**RE: Ashtabula Wind II, LLC – Ashtabula Wind II Energy Center, Griggs and Steele Counties, North Dakota (Case No. PU-09-221)**

# NextEra Energy - Ashtabula Wind II, LLC

## Turbine 179 Location Detail

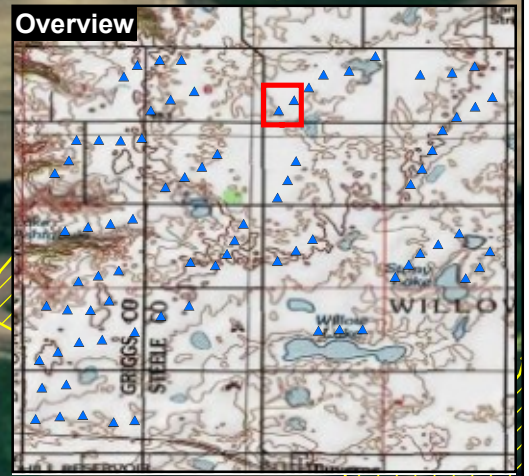
After identifying the easement boundaries, it was determined that one of the turbines, Turbine 179, was located in a USFWS wetland easement. In order to avoid impacting this wetland, Turbine 179 should be moved approximately 156 ft north of the old location to avoid the wetland. The associated collection line and road will also be moved. Please see the attached figure showing the original and newly proposed location.
